**PLANNED UNIT DEVELOPMENT,
SIDEWALK WAIVER REQUEST &
SUBDIVISION STAFF REPORT****Date: November 7, 2013**

<u>NAME</u>	Audubon Properties, LLC.
<u>SUBDIVISION NAME</u>	<i>Dockside Marina Subdivision</i>
<u>LOCATION</u>	4700 & 4960 Dauphin Island Parkway West side of Dauphin Island Parkway, 580'± North of Marina Drive North).
<u>CITY COUNCIL DISTRICT</u>	District 3
<u>PRESENT ZONING</u>	B-3, Community Business District
<u>AREA OF PROPERTY</u>	11.01 ± Acres/ 1 Lot
<u>CONTEMPLATED USE</u>	Planned Unit Development Approval to allow multiple buildings on a single building site, and a Sidewalk Waiver to waive construction of a sidewalk along Dauphin Island Parkway, <i>and Subdivision approval to create one legal lot.</i>
<u>TIME SCHEDULE FOR DEVELOPMENT</u>	Immediate

SITE PLAN

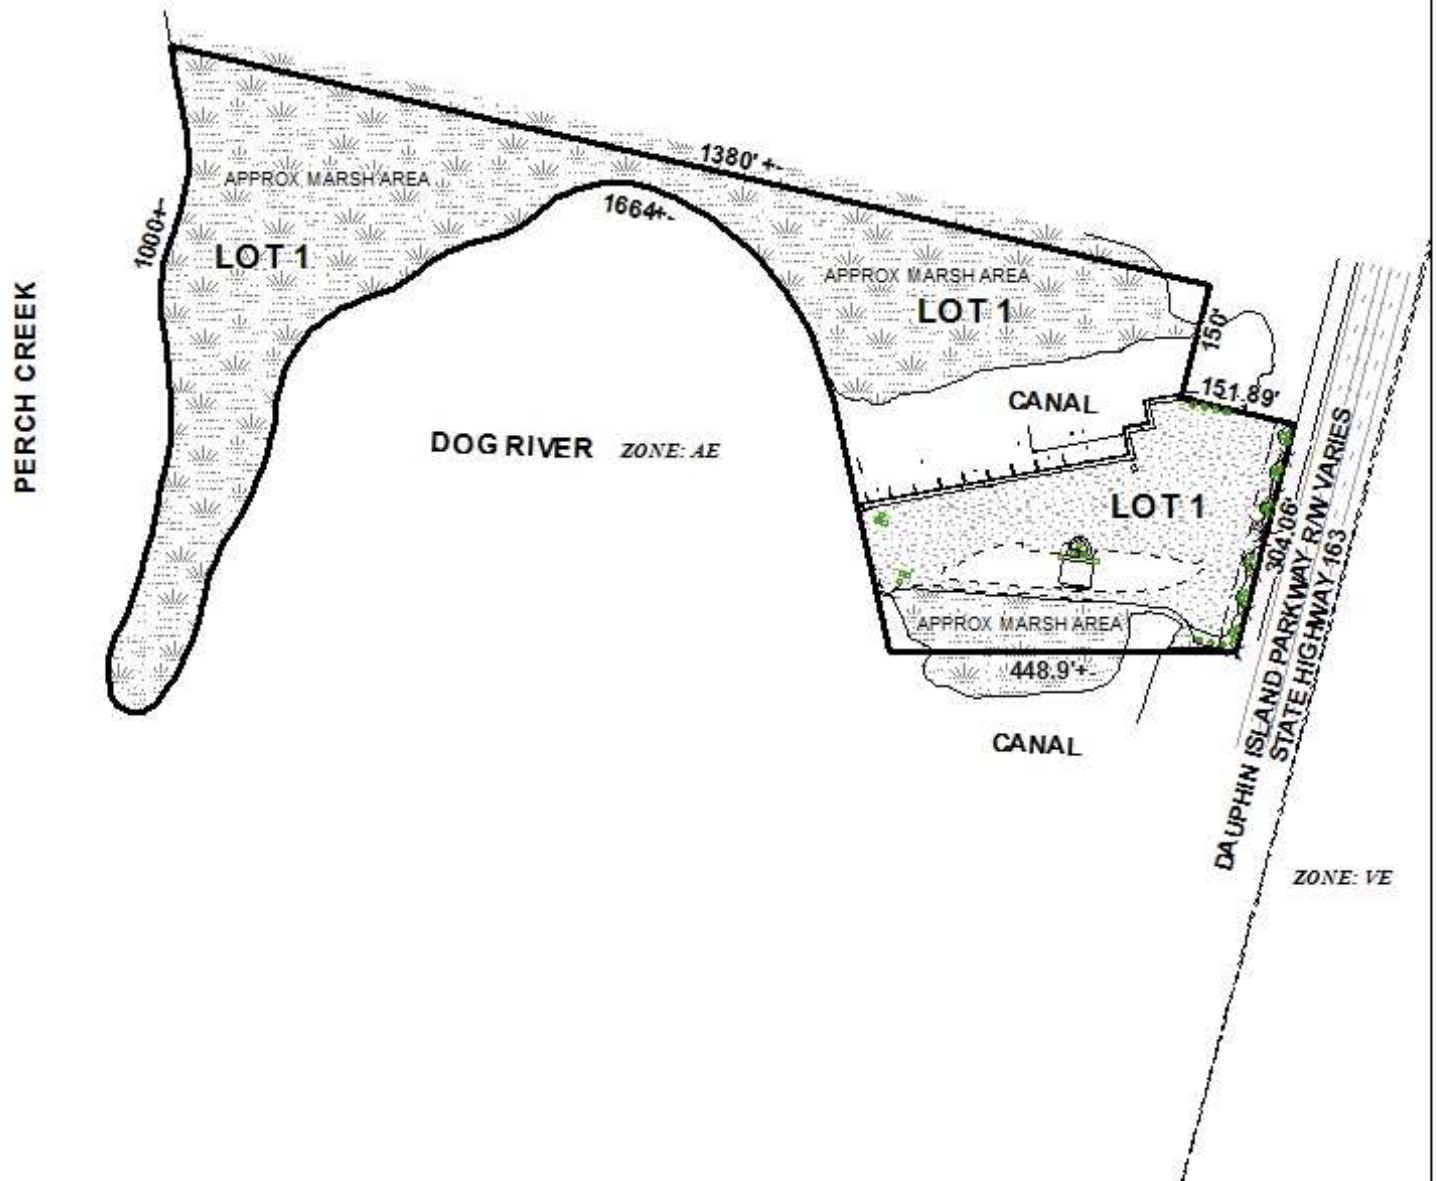
It appears, generally, that the number of parking spaces will be adequate for the proposed use and the site plan depicts each parking space with a wheel stop, however, there appear to be no accessible parking spaces shown on the plan. The applicant should verify if accessible parking will be required. If accessible parking is required, a revised site plan depicting the revised parking spaces will be required.

The site currently has an existing iron fence and gate that runs along the right-of-way frontage of Dauphin Island Parkway. The gate should be modified to provide a 60' queuing distance from the right-of-way line. It appears the existing driveway is not 24' wide as required by the Zoning Ordinance, thus modifications should be made to address this issue. The labeling of the right-of-way width along Dauphin Island Parkway should also be illustrated on the site plan.

A screened enclosed dumpster is noted and depicted on the site plan. However, there is no indication that the dumpster will be connected to sanitary sewer. The site plan should be revised to indicate if the dumpster will be connected to sanitary sewer. All other notes displayed on the site plan should be retained on any revised plans.

- 1) submission of a subdivision application;
- 2) revision of the site plan to illustrate accessible parking spaces;
- 3) revision of the site plan to depict correct calculations of trees or the number of trees illustrated on the site plan;

- 4) revision of the site plan to show the relocation of the existing gate to provide a 60' queuing distance from the right-of-way line;
- 5) labeling of right-of-way width of Dauphin Island Parkway on site plan;

- 6) revision of the site plan to indicate a driveway width of 24';
- 7) placement of a note on the site plan stating that approval of all applicable Federal, state and local agencies is required for endangered, threatened or otherwise protected species;

- 9) revision of the site plan to indicate the dumpster will be connected to sanitary sewer;
- 10) retention of all other existing notes on any revised plans;

This application was heldover from the November 7th meeting to allow the applicant to submit a subdivision application and a revised PUD site plan. A revised PUD has been submitted and it appears that all of the previous conditions have been met with the exception of the tree and landscaping condition.
